RFB-2024-62
SUNY SCCC ROOM 220G RENOVATIONS, NEW SKYLIGHTS & ELSTON BUILDING FAÇADE
WINDOW WORK

ADDENDUM #2

Issued Date: 1/17/2025

1
D104 Elston Roof Demolition Plan (Add Alternate #03)
SCALE: 1/8" = 1'-0"

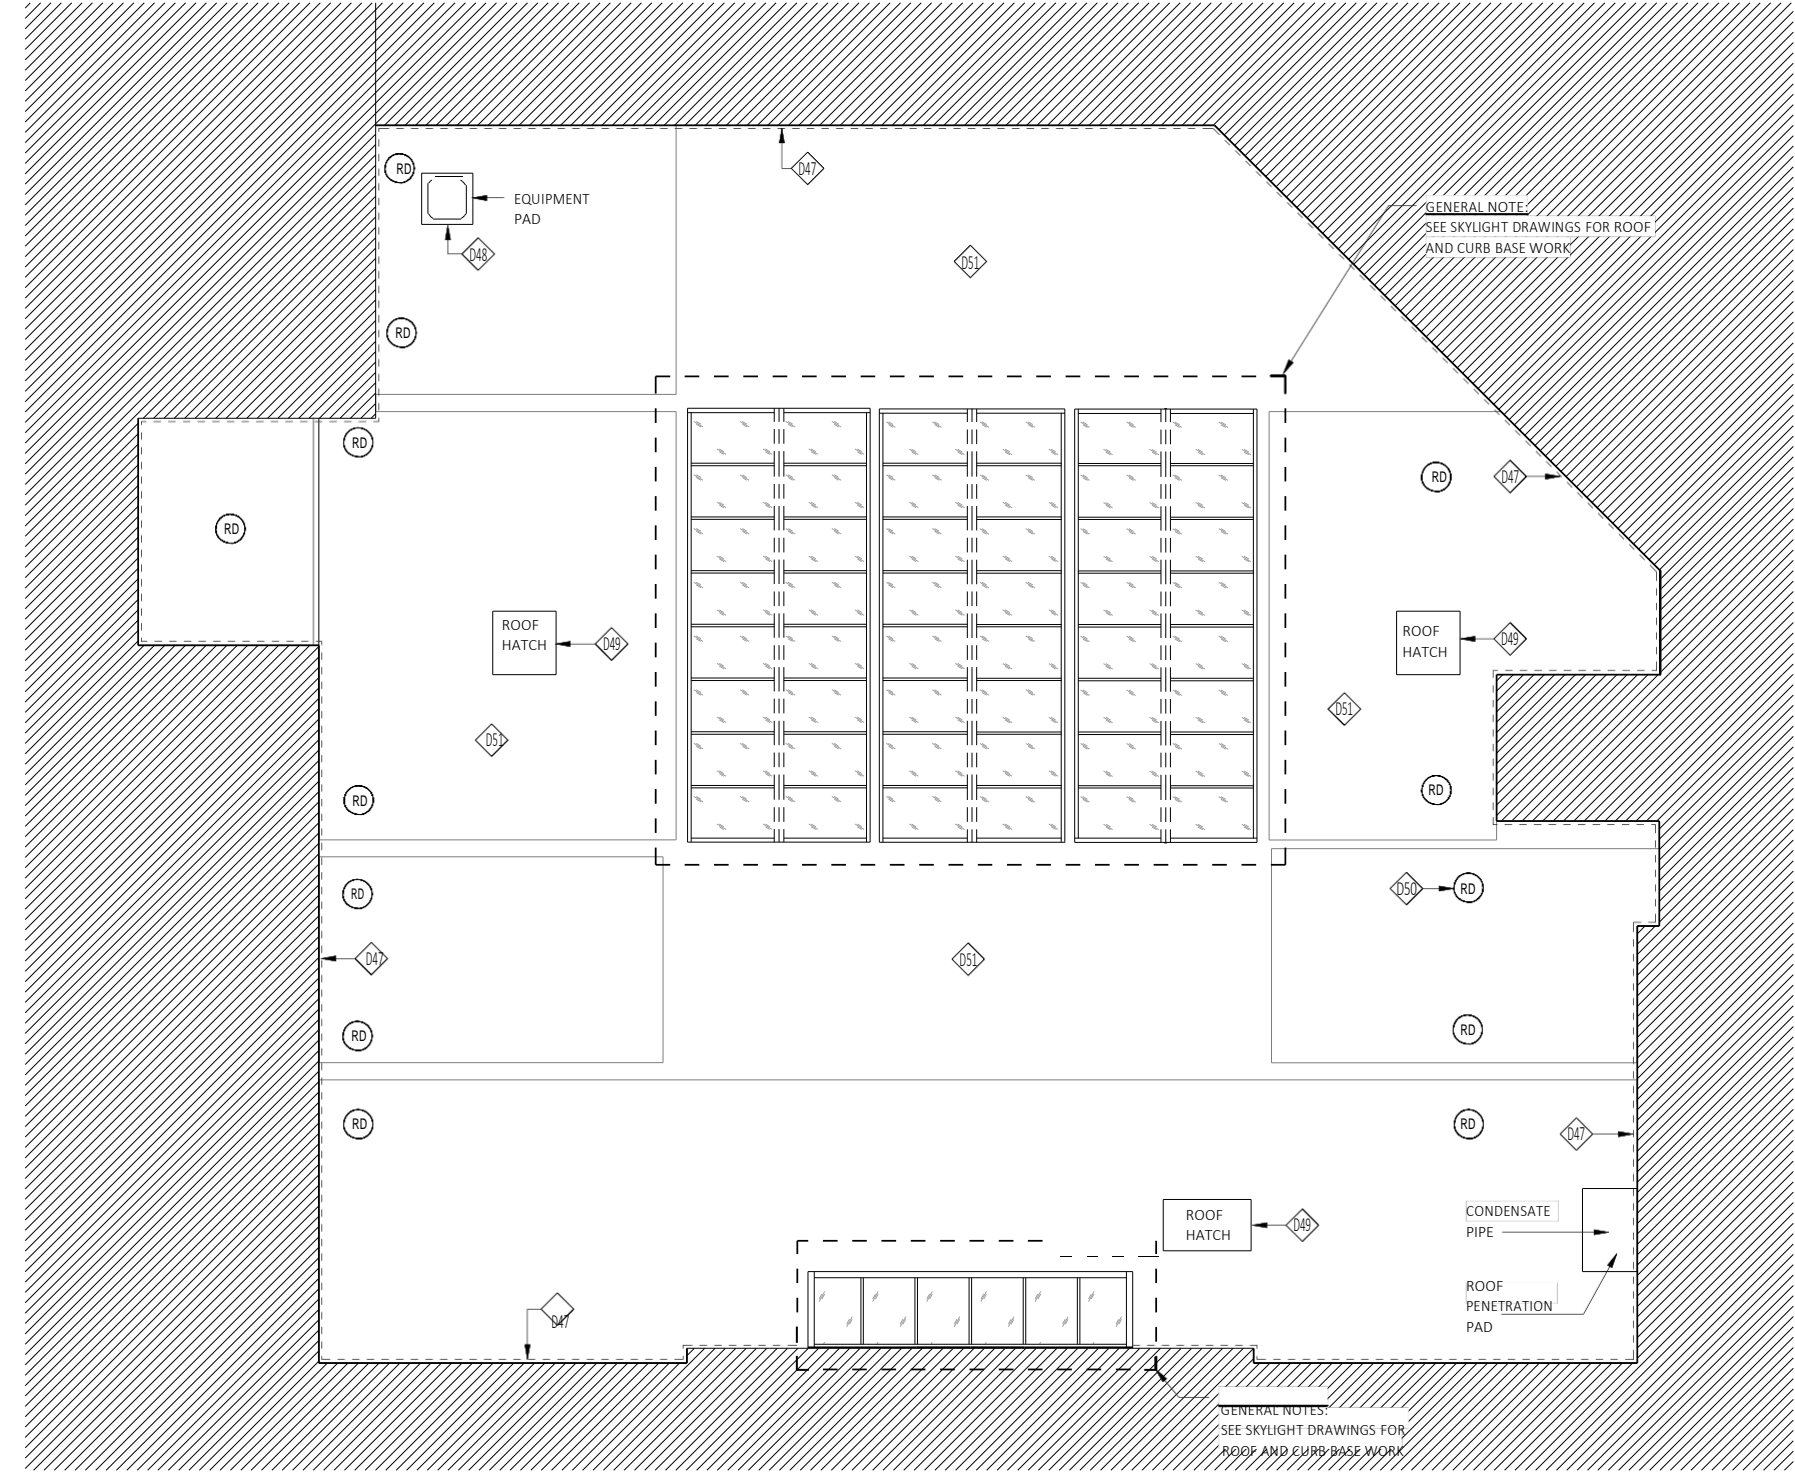
1. Drawing D104 – Elston Roof Demolition Plan
 - a. New Drawing - Addendum #2
2. Drawing A103 – Elston Roof Plan
 - a. New Drawing - Addendum #2
3. Drawing A604 – Elston Roof Details
 - a. New Drawing - Addendum #2
4. Specifications Division 0 – Bid Submission Checklist
5. Specifications 00 02 00– Notice to Bidders
